FINAL DRAINAGE REPORT
for
SILVERADO RANCH FILING NO. 2

January 31, 2024
Revised June 7, 2024

JPS Project No. 080603
PCD Project No. SF246

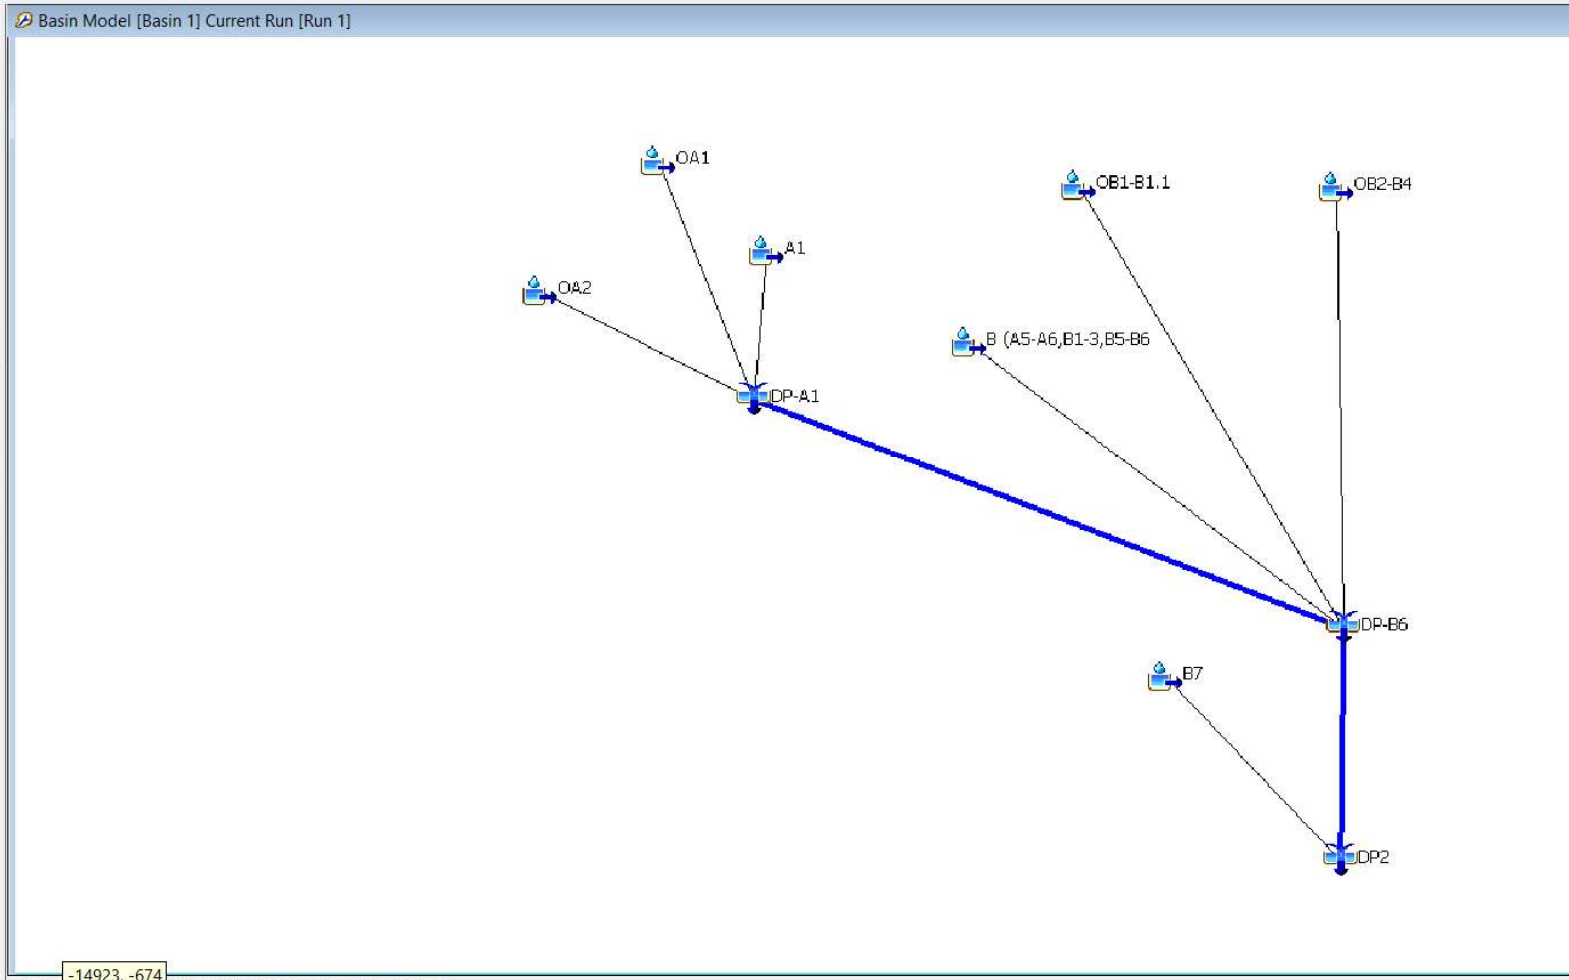
Unresolved:
Provide flows for DP OB1

FILING NO. 2 DEVELOPED DRAINAGE PLAN

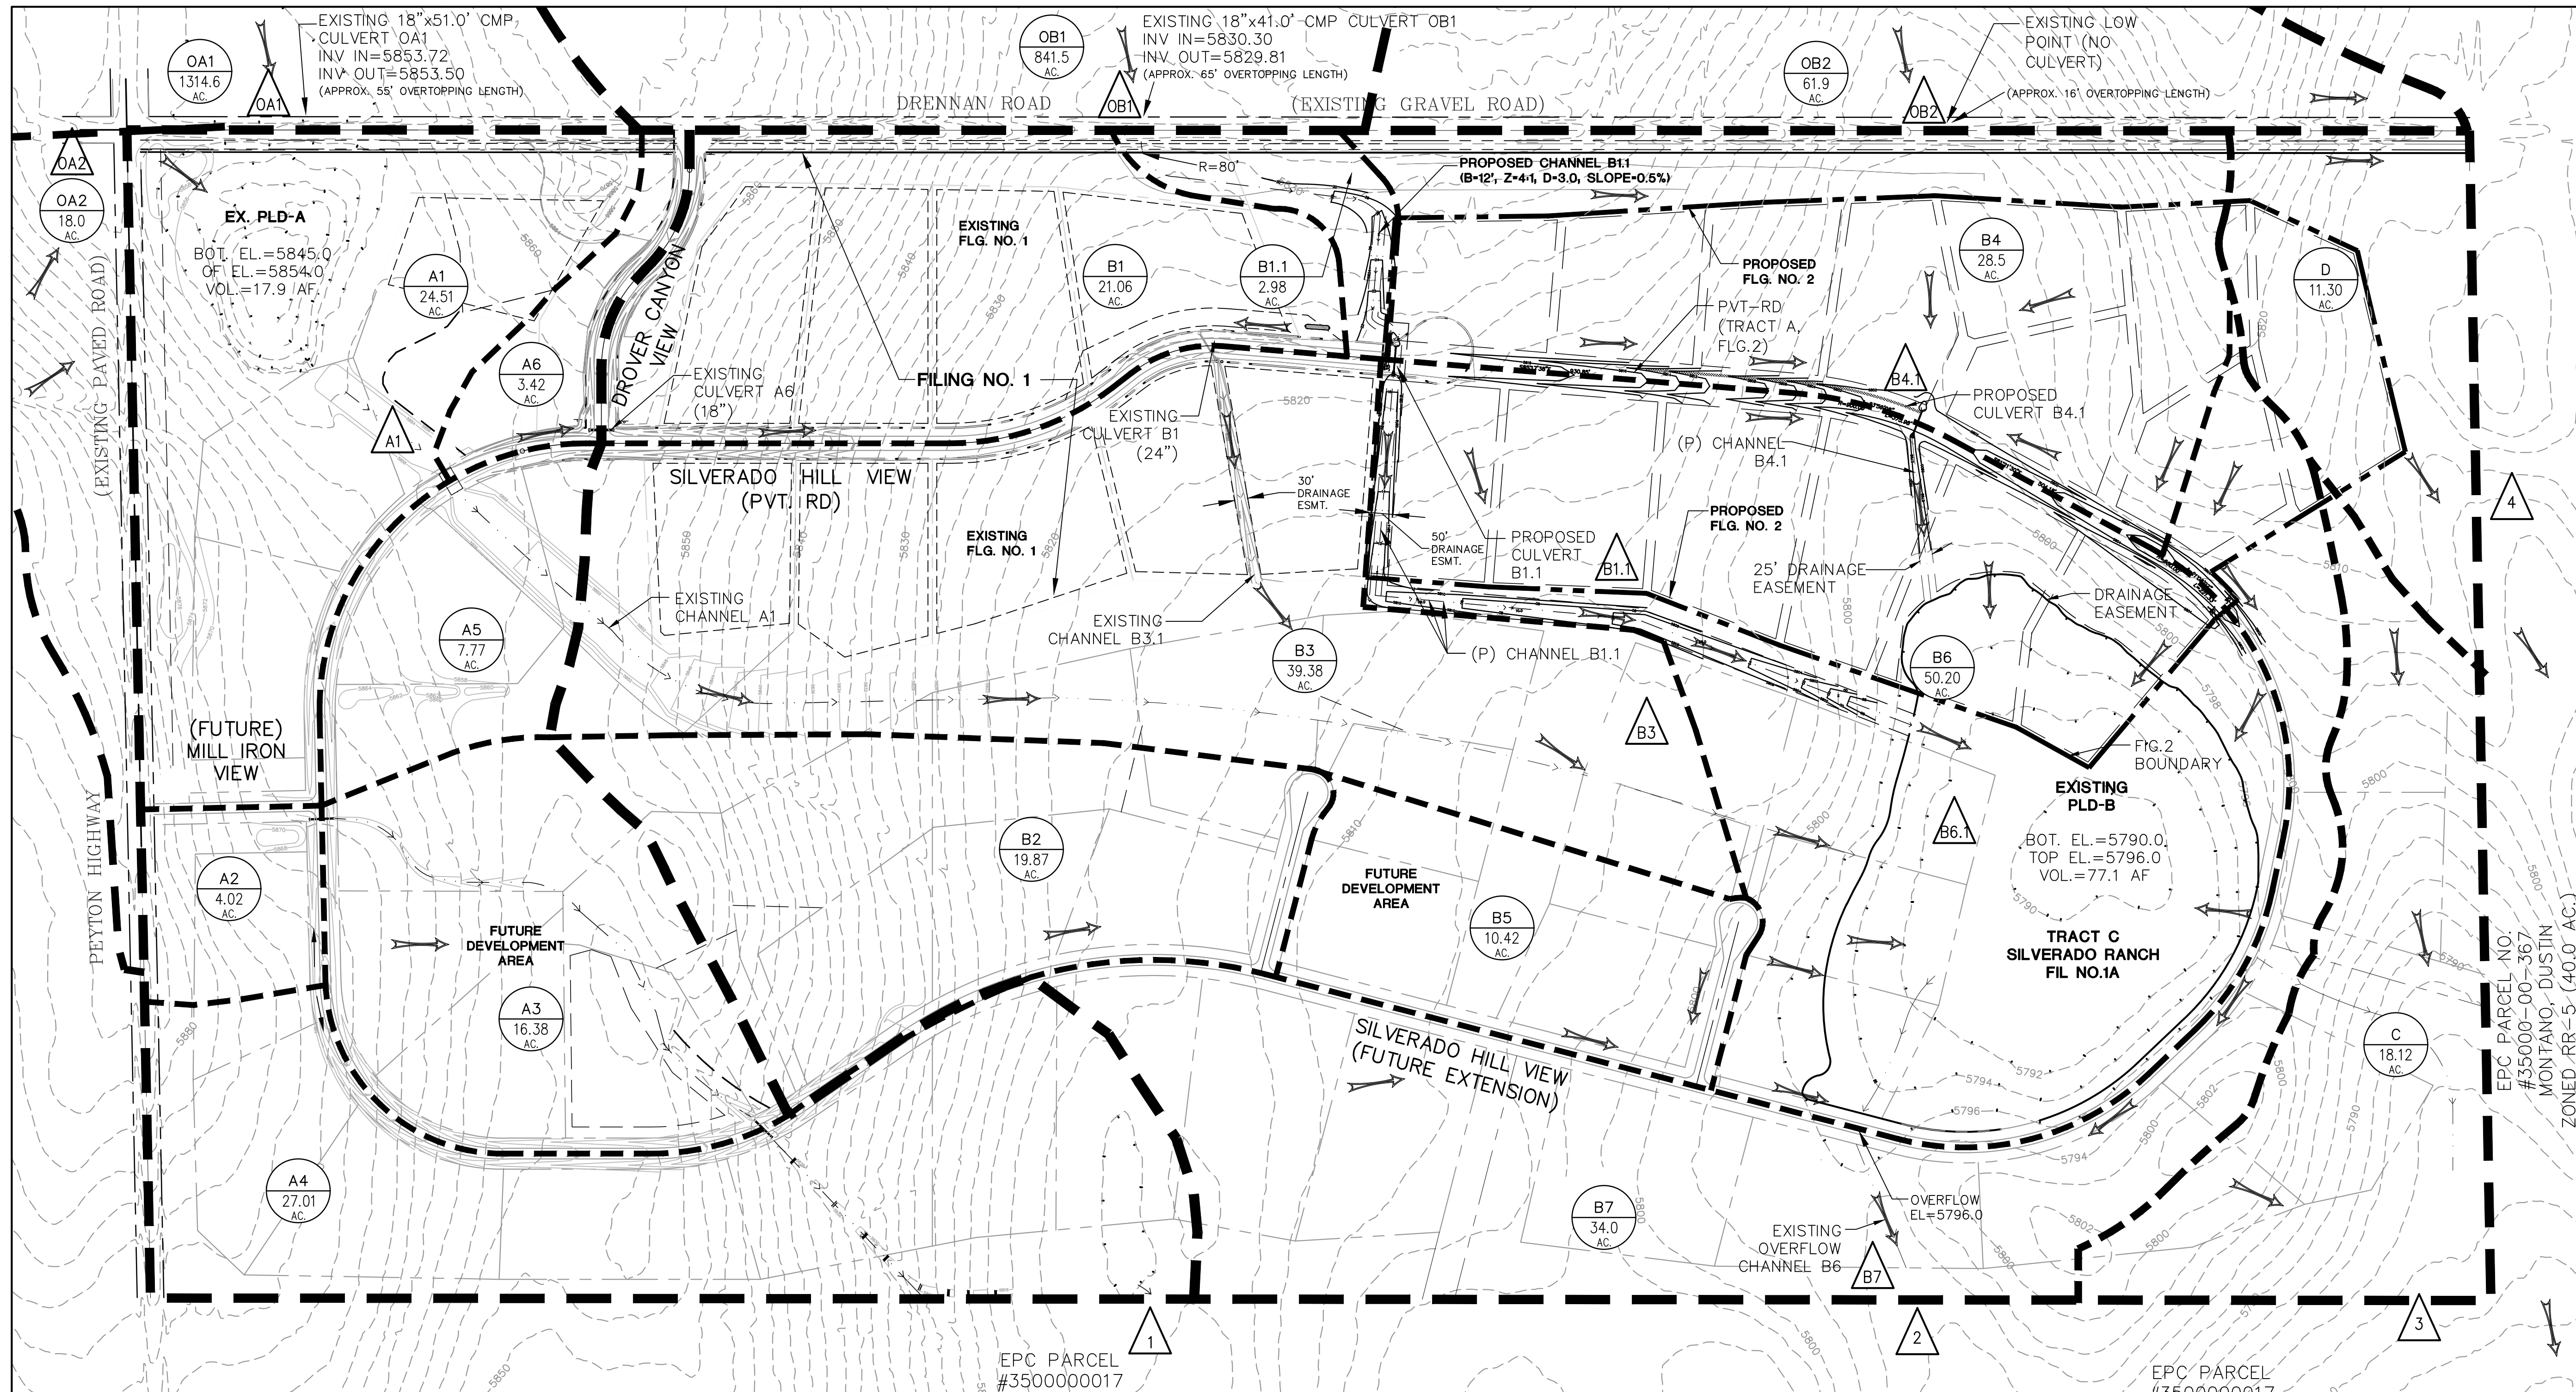
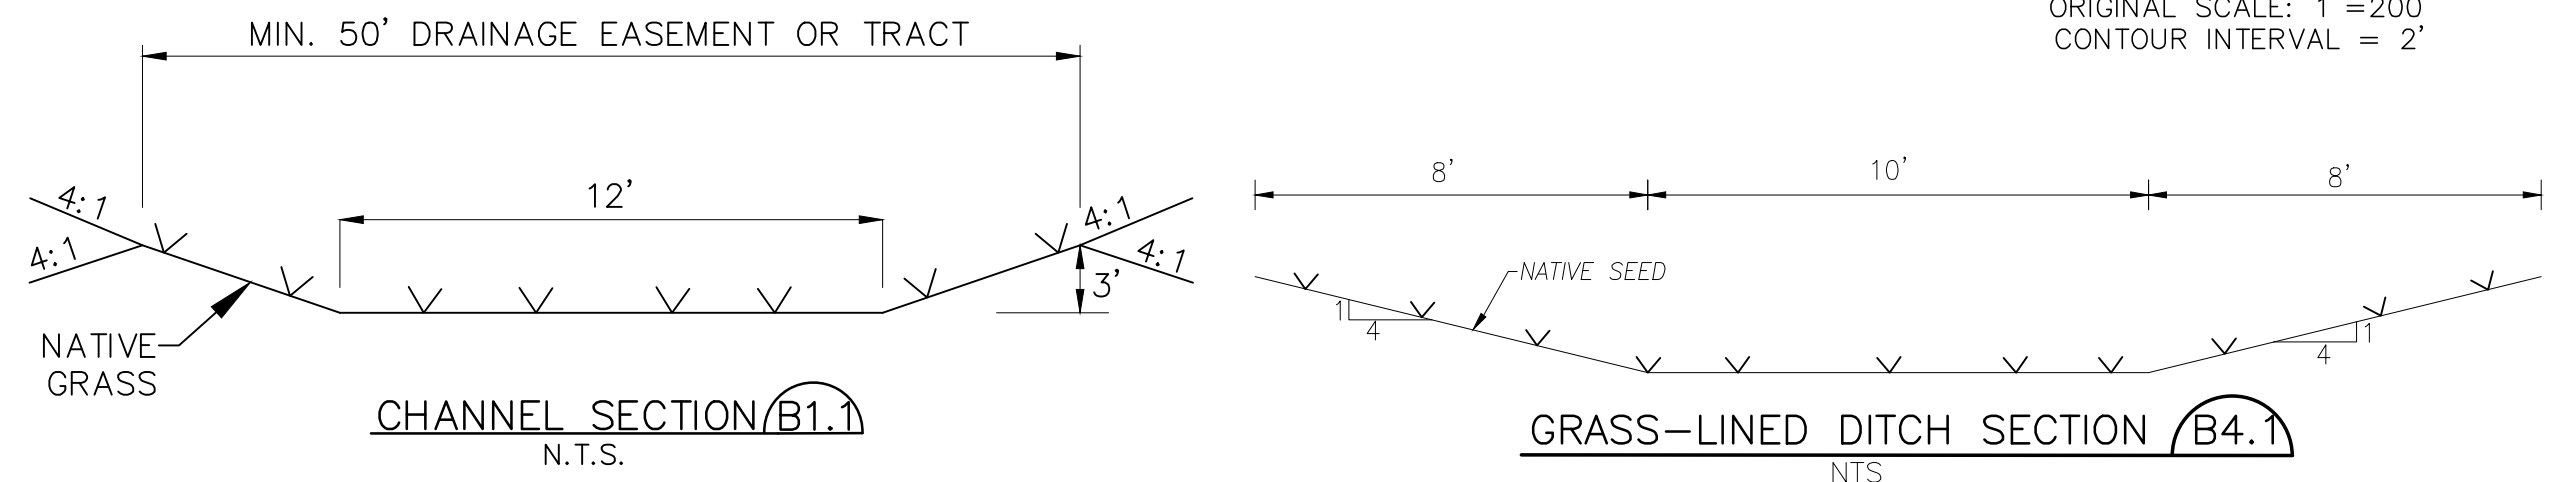
Please see comment on the drainage map for pond improvement to meet the current criteria.
